1. Agenda For August 2020 Zoning Board Of Appeals

1.I. Appeal 2232 - 22 Durkee St - SUP

1.I.i. Revised Site Plan And Parking Analysis

DRAWING NUMBER
C-01
 01 OF 01

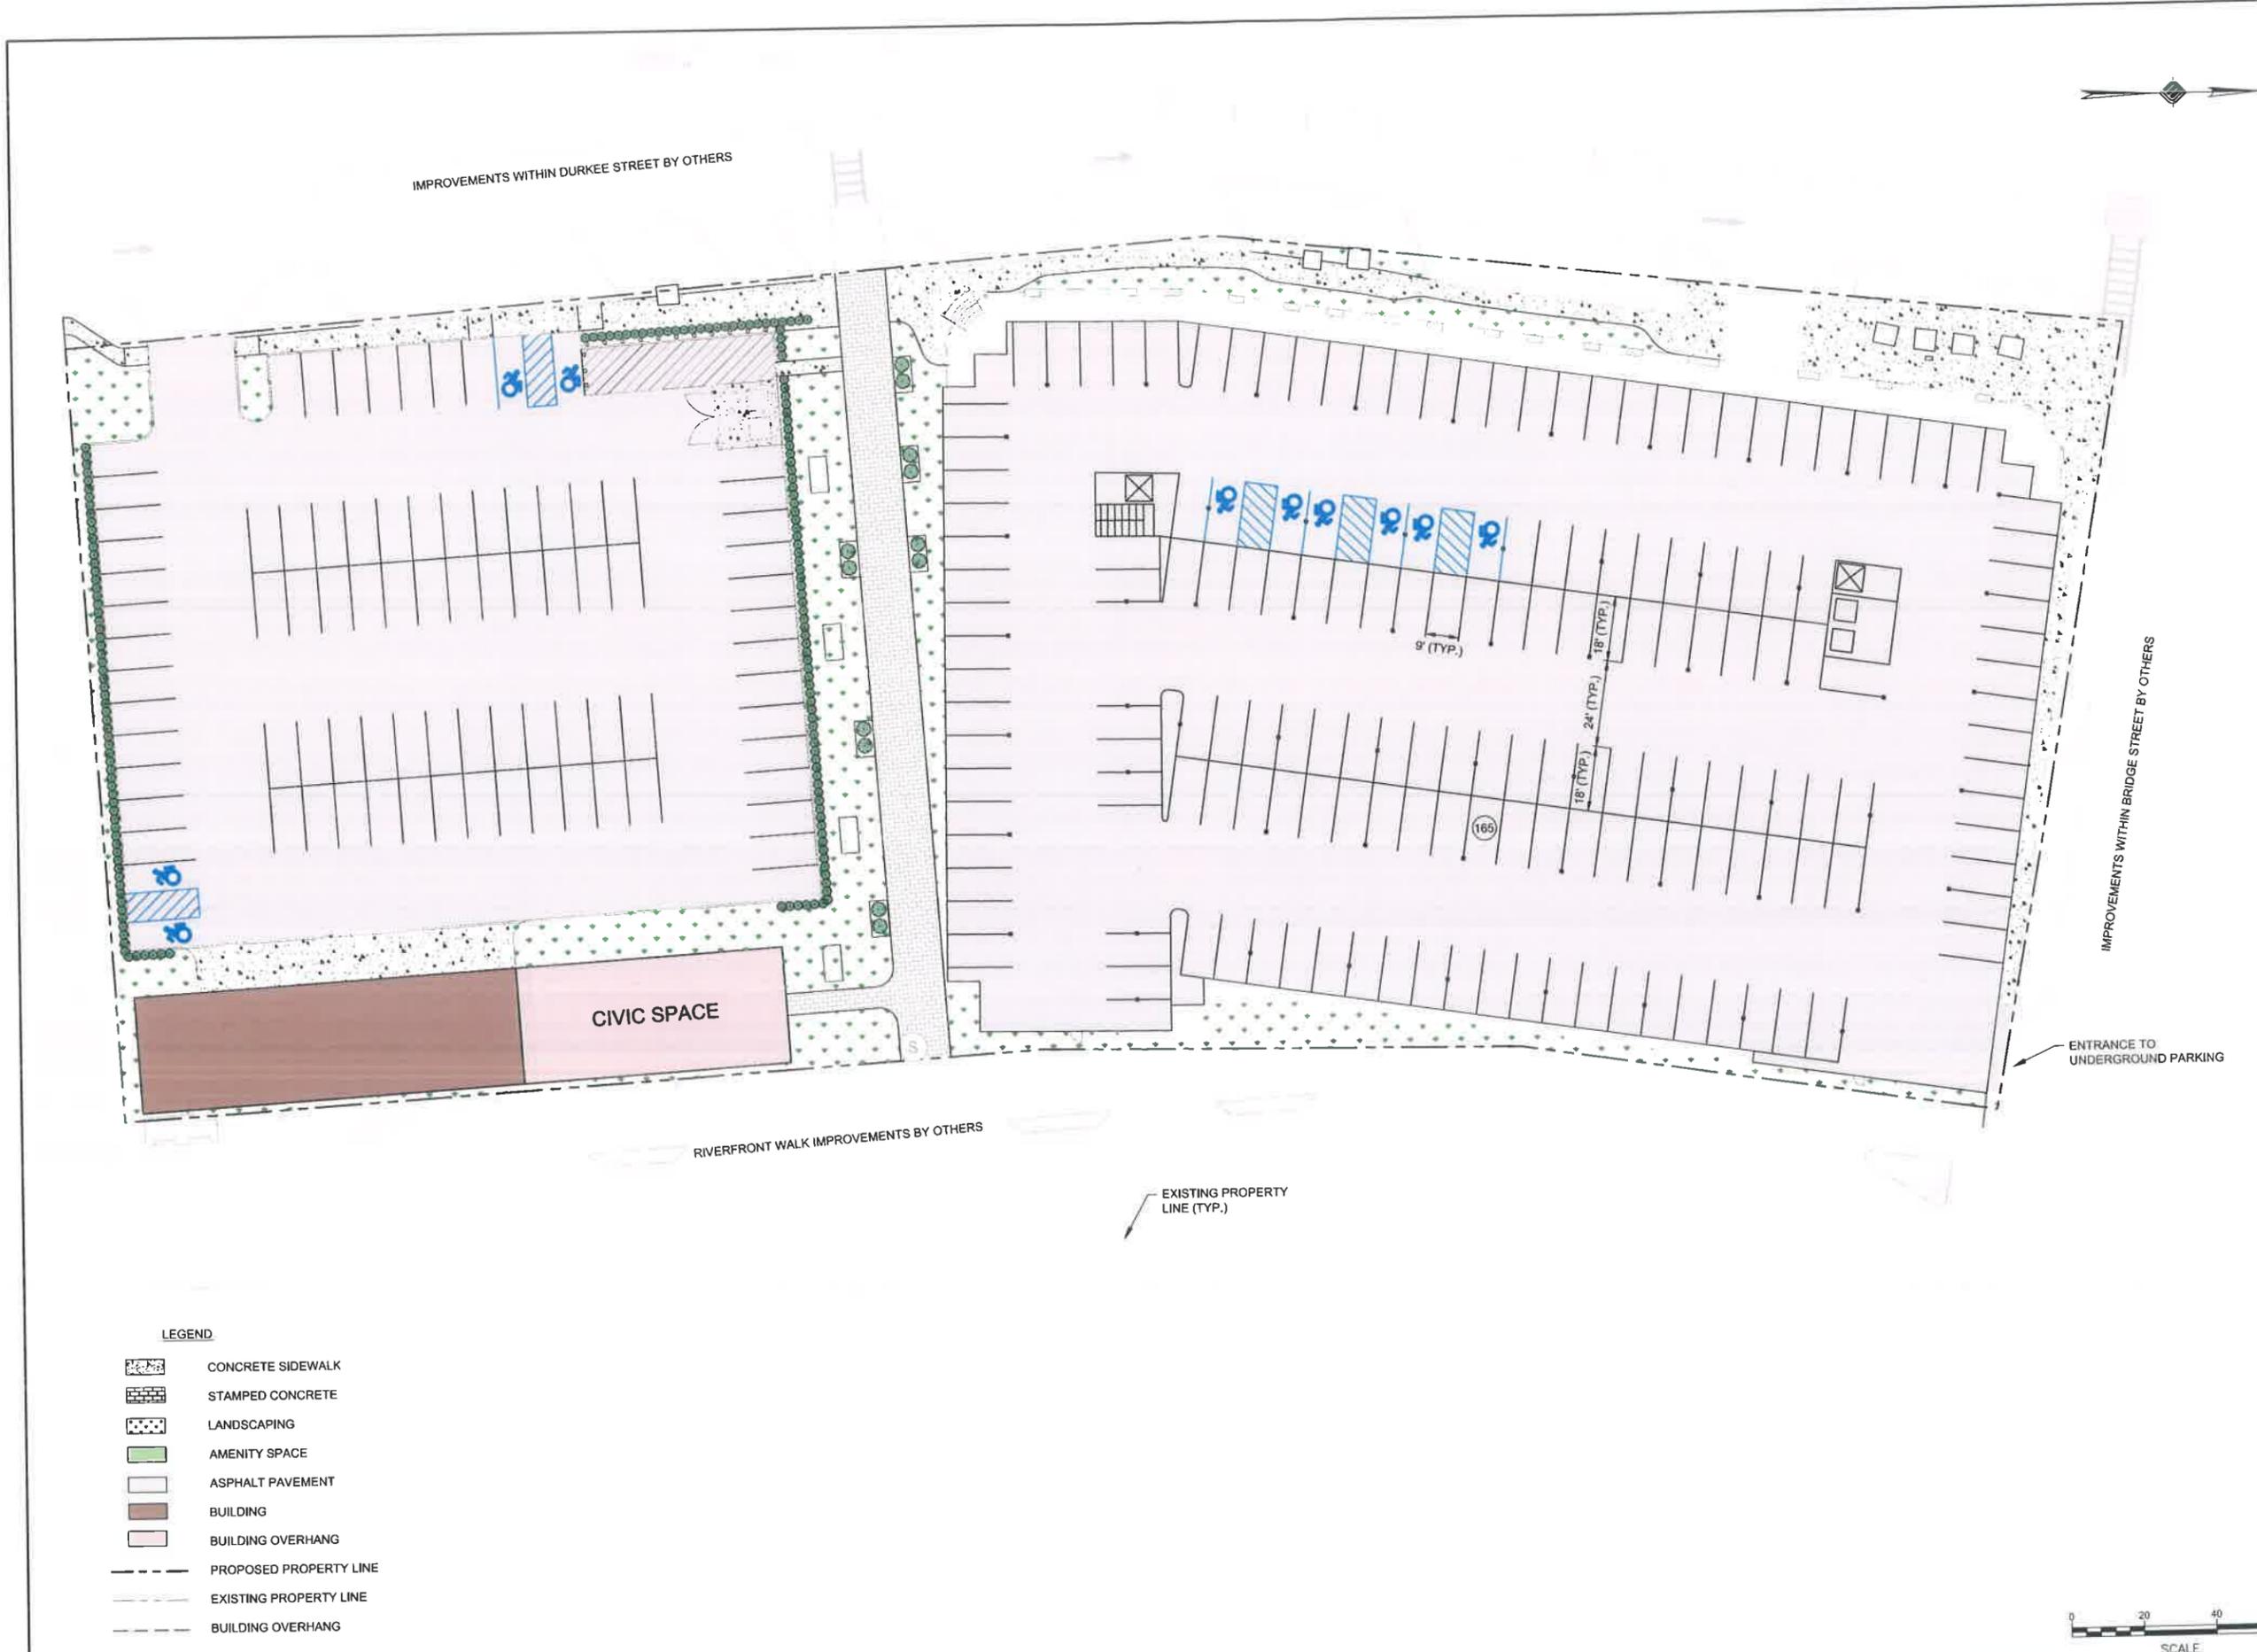
9. Please add dimensions to all existing and proposed buildings, parking areas, and public spaces (sidewalks and pedestrian corridor).
Dimensions have been added to the Site Plans and are shown on sheet C-01.

10. Please show all required/provided setbacks.
Setbacks have been added to the Site Plans and are shown on sheet C-01.
 11. Please provide a stormwater management plan, which complies with NYSDEC stormwater regulations.
A full Stormwater Pollution Prevention Plan (SWPPP) has been prepared and is included with this submission.

18. Please provide an erosion control plan.
Erosion control plans provided, see sheets EC-01 and EC-02.
19. It is recommended that the Applicant be required to show proposed snow stockpile areas on the plan.
Snow stockpile areas have been provided and are shown on Site Plan sheet C-01.

32. Please identify any on-site playground amenities for residents.
No on-site playground amenities are included.
33. It is recommended the project provide two (2) bike racks for public use on site.
Bike rack locations are shown on sheet C-01.

34. Please provide additional information and note on the map any on site electric vehicle charging stations.
Electric vehicle charging station locations are shown on sheet C-01.
